Memorandum

December 17, 2007

**Re: Planning Commission Agenda Item – Biddulph Trail Cluster Homes,
25747 Butternut Ridge Road**

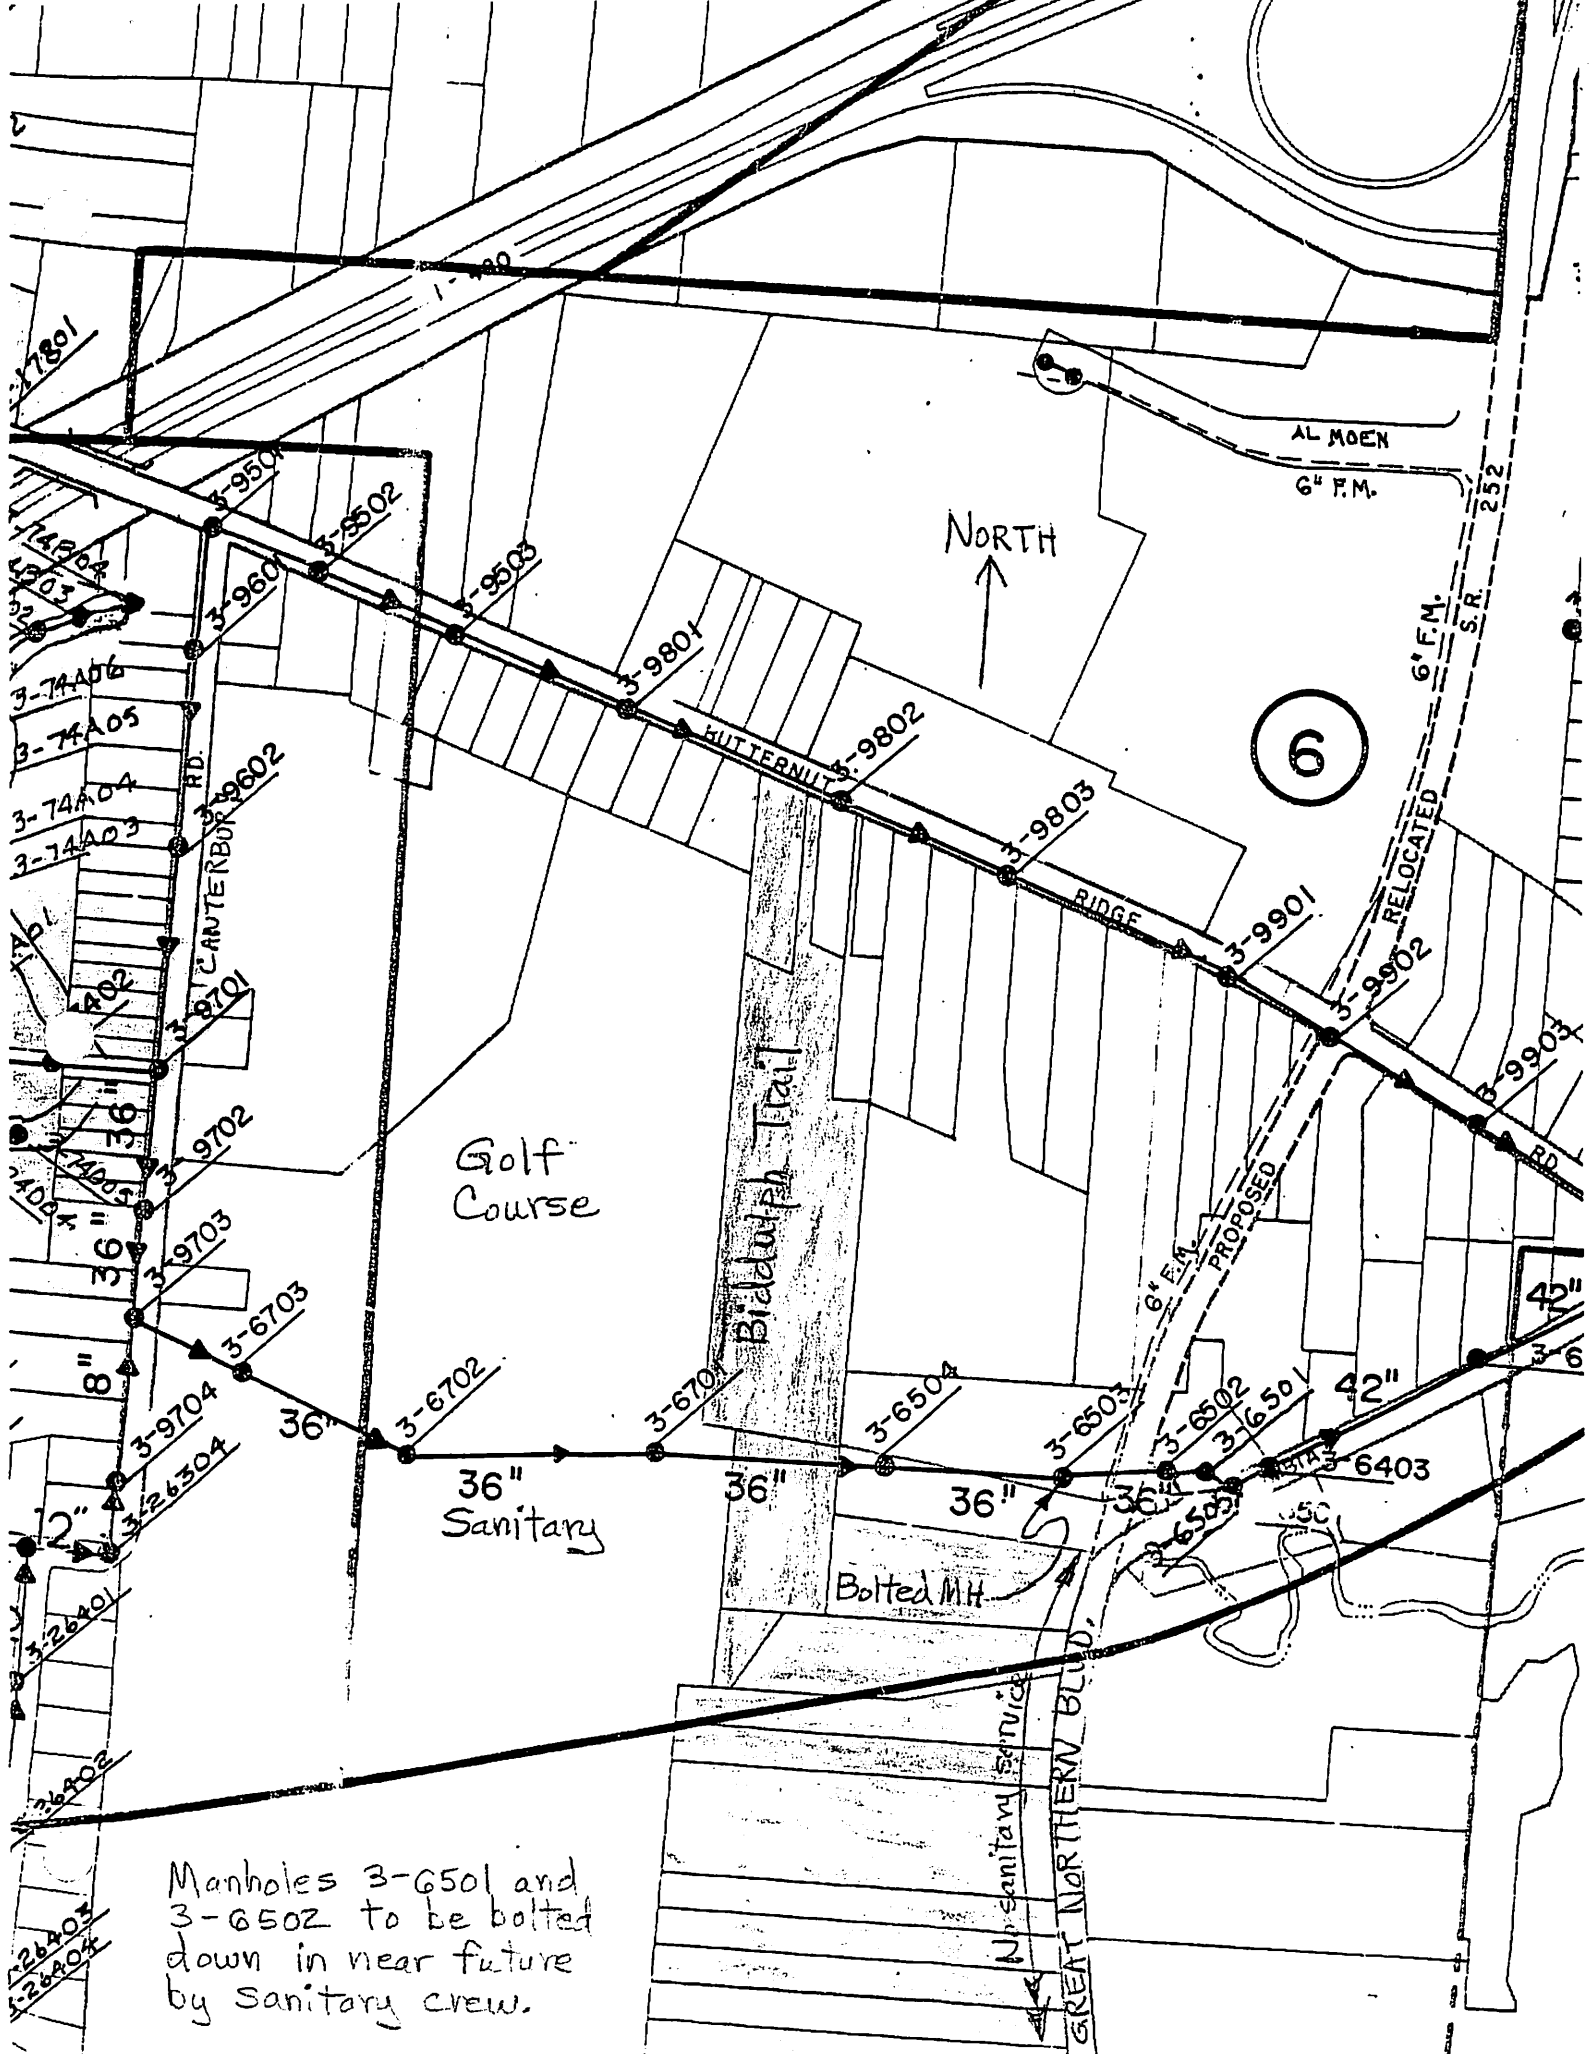
See the attached report from Sanitary Sewer Supervisor Bob Binggeli. Sanitary Sewer Supervisor Bob Binggeli plans to bolt down two additional manholes on the east side of Columbia Road in the near future to prevent those from surcharging.

Manholes 3-6501 and 3-6502 to be bolted down in near future by Sanitary crew.
